Re: Lot 19, Shackel Avenue, Gladesville.
Building Application No. 1075/86

Shackel Avenue, Gladesville, Lot 19 (6).
Building Application No. 1075/86.
Class 1 Building.

PROJECT NEW RESIDENCE
LOT 19 SHACKEL AVE
GLADESVILLE
PROJECT No. 1023

Drawing Title
Dwg. No. 1023/3 B

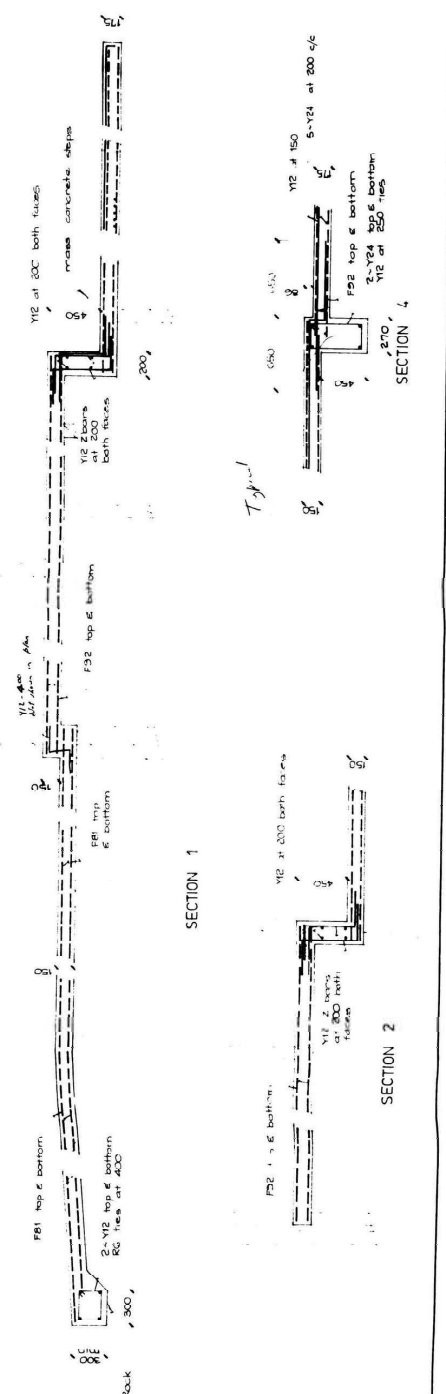
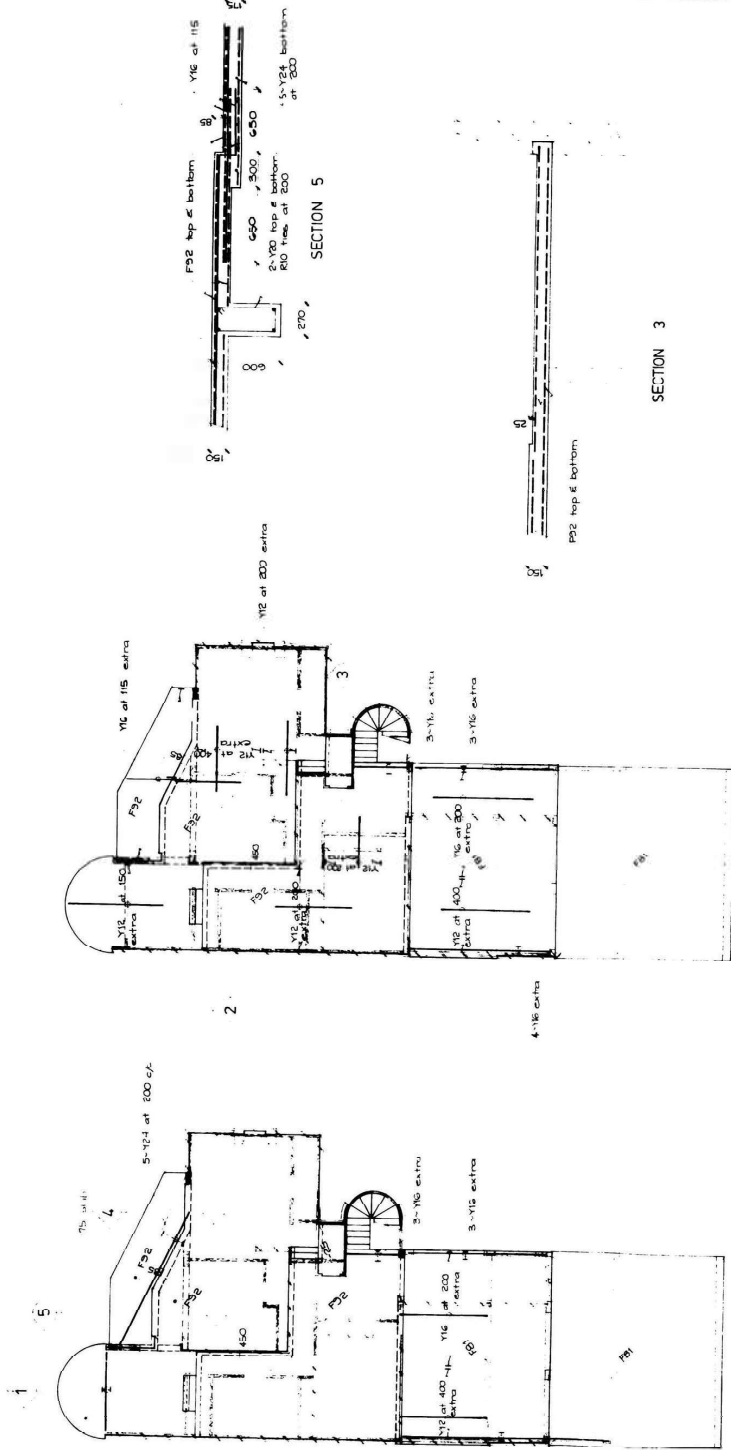
1. Strength and deflection of cantilever balcony on Level 3.
2. The laying sequence of bars and mesh.

- (i) The slab has been redesigned. Drawing 1023/3 has been amended to suit this redesign, 3 copies of 1023/3C are attached.
- (ii) A slab band has been introduced spanning from load-bearing brickwork to the door head beam. This slab band reduces the balcony cantilever.
- (iii) The working stress of the reinforcement resisting the cantilever moment is 58.0 MPa.
- (iv) The reinforcement has been detailed to provide continuity across the slab step-down.
- (v) The laying sequence of bars and mesh is clearly shown on the sections on each of the drawings.

Drawing Title
Dwg. No. 1023/2

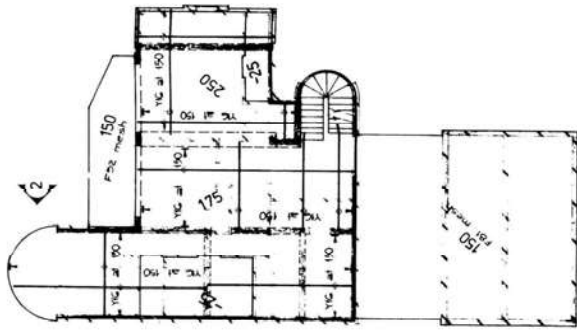
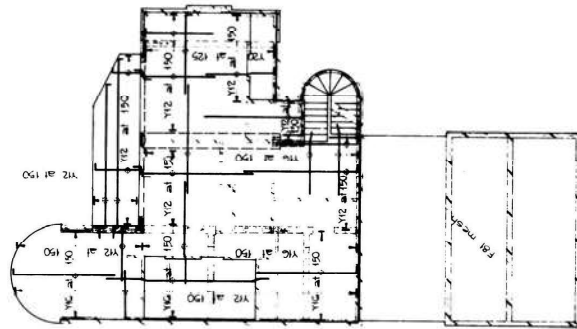
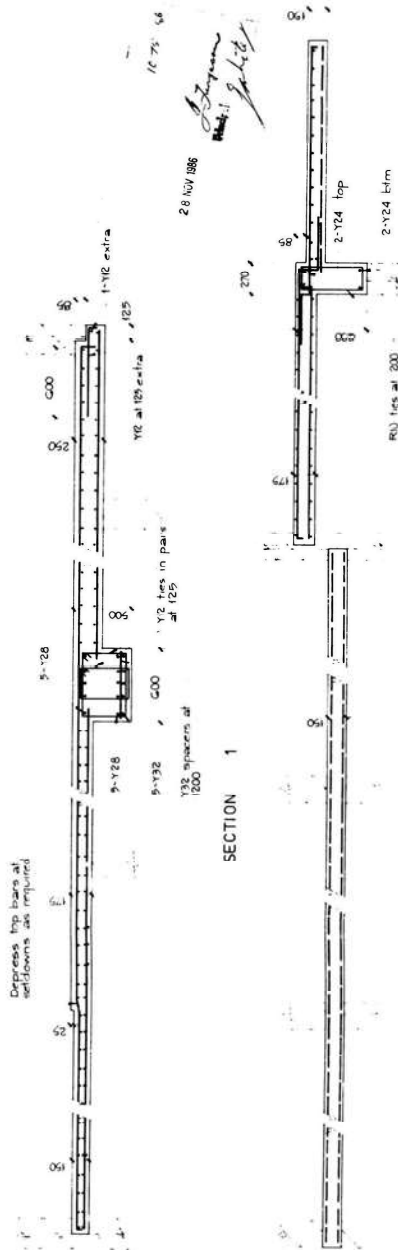
Bars in this direction to be laid first if used in one

Drawing Title
Drg. No. 1023/3 B

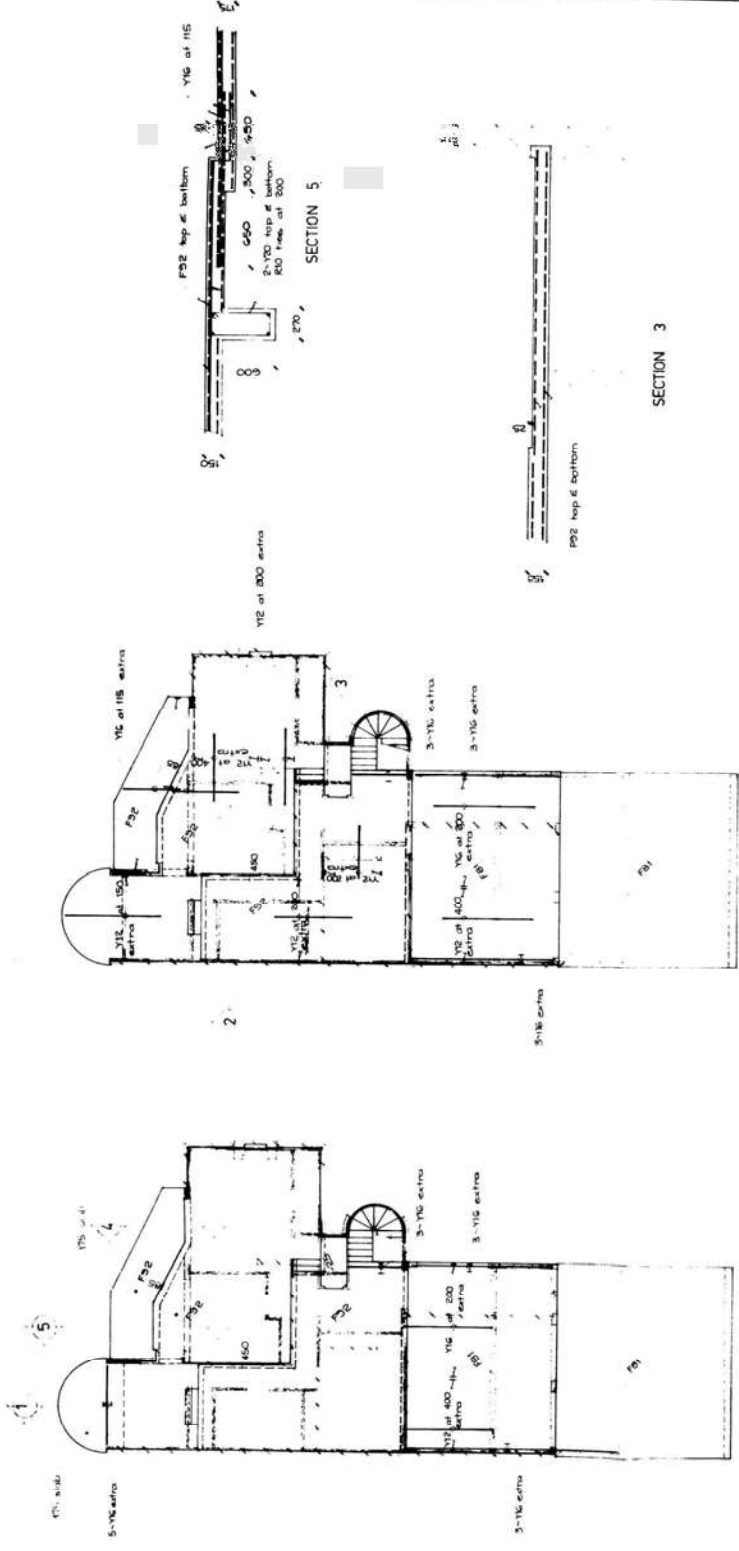
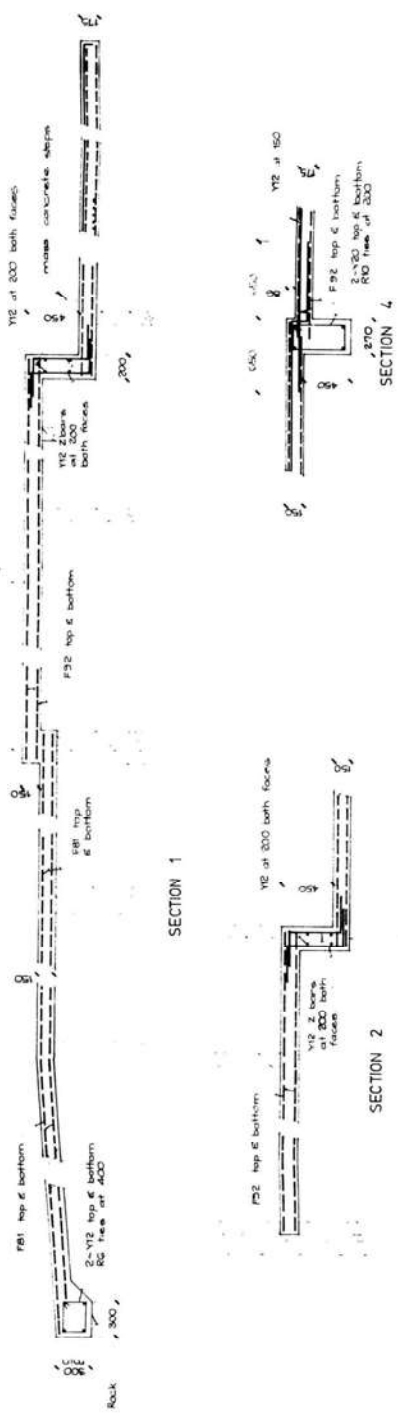
1. Strength and deflection of cantilever balcony on Level 3.
2. The laying sequence of bars and mesh.

DESCRIPTION	Date	By
Section 1, 4, 5 amended	10-11-86	
Section 3, 4, 5 reinforced	10-11-86	
Finality note revised	10-11-86
